ADDENDUM NO. 2

GMIA-Runway 7R Deice Pad

PROJECT NO. A158-12009

DATE OF ADDENDUM: July 11, 2014

GENERAL MITCHELL INTERNATIONAL AIRPORT
RUNWAY 7R DEICING PAD

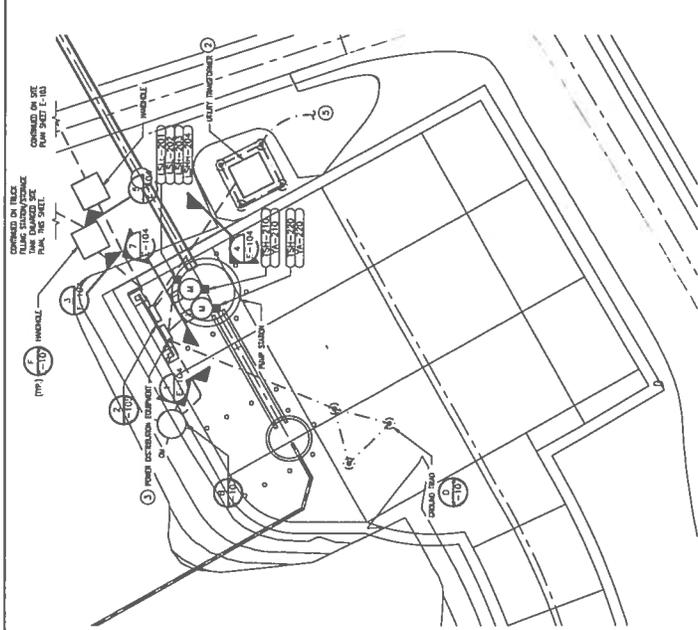
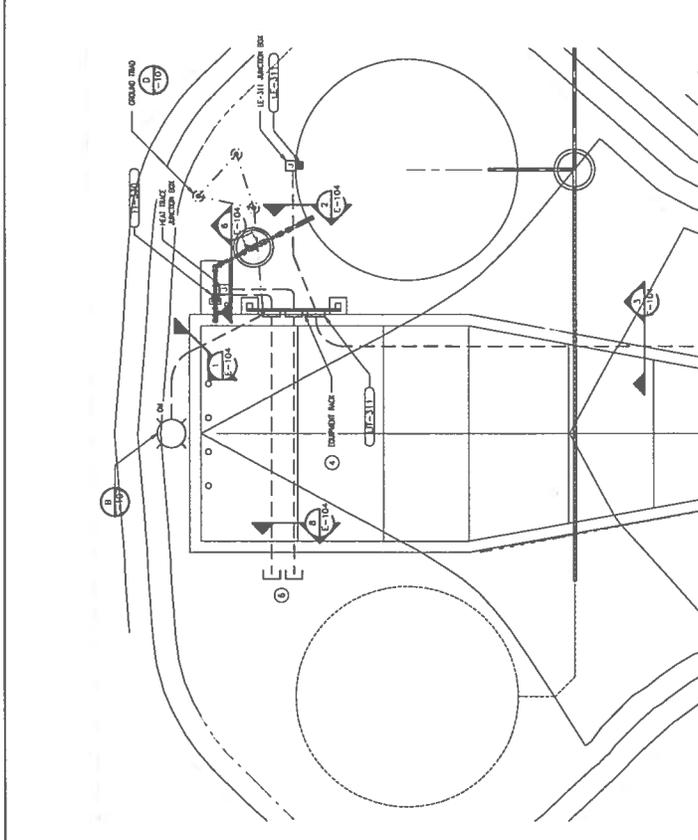
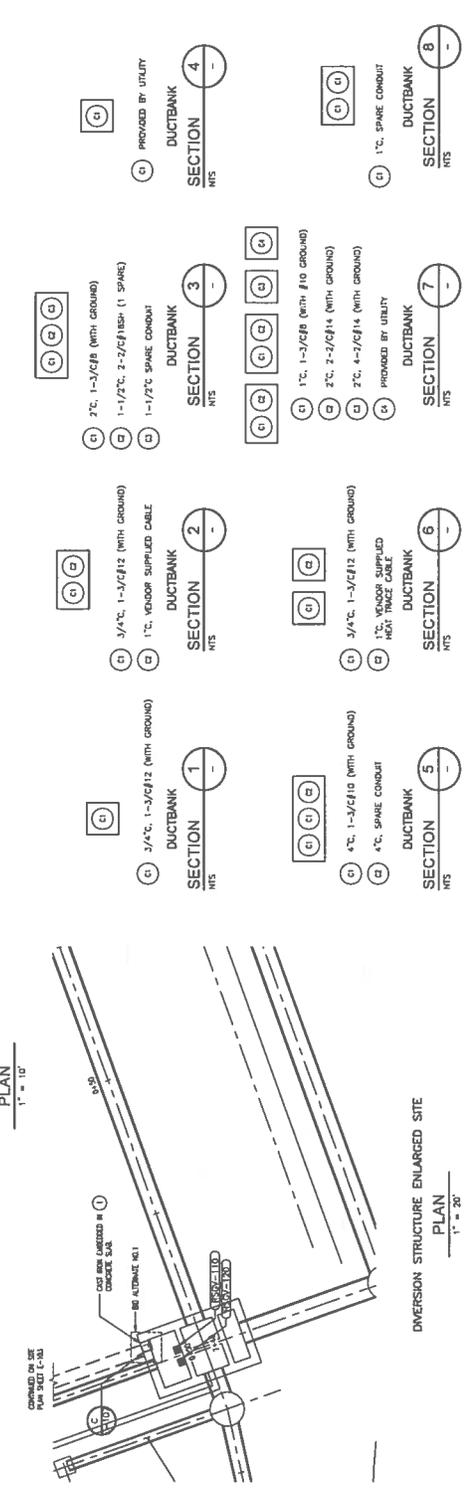
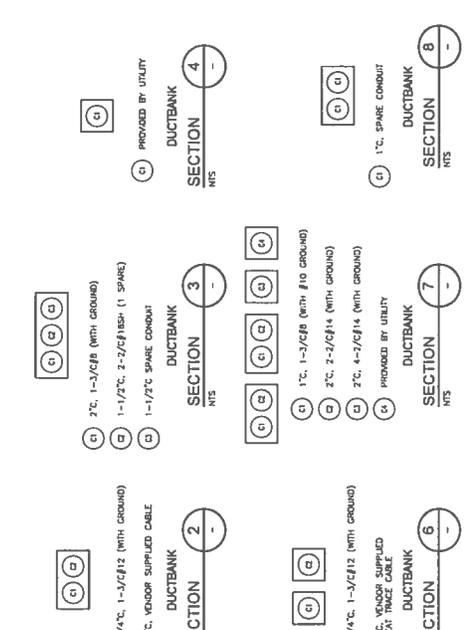
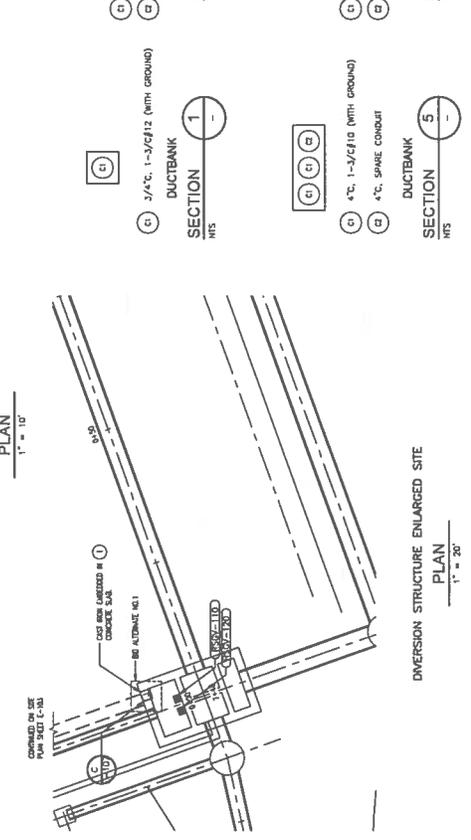
A thickened concrete edge should be installed along the existing cargo apron pavement.
2. The "E" joint detail -Sheet C-011 shall be used where the "D" is shown on pages C-014 & C-014.
3. 9" driveway pavement plan view & Joint plan information is shown on Sheets C-152 and C-156 through C-166.
4. Replace sheet E-104 & E-105 with attached sheets.

1. Electrical Distribution Equipment
 - 1) Mini Power Zone 7R-DP2 is shown twice on panel schedules on E-106. Please provide panel schedule for 7R-DP1 and 7R-DP2 if they are different or confirm that they have identical loads. **Panelboard 7R-DP2 is shown twice. See Revised Drawing E-106 (Attached).**
 - 2) Where are schedule disconnect switches for RSGV 110 and RSGV 120 (Diagram 3 E-105) intended to be physically located? Disconnect switches are to be installed in the diversion

chamber. Refer to keynote 22. See revised drawings E-104 (Attached) and E-105 (Attached).

- 3) With regard to Diagram 3 on E-105, is Underground Junction Box actually intended to be (precast) handhole? **The junction box can be a pre-cast handhole as long as it is partitioned and cast into the concrete slab. See revised drawing E-104 (Attached).**
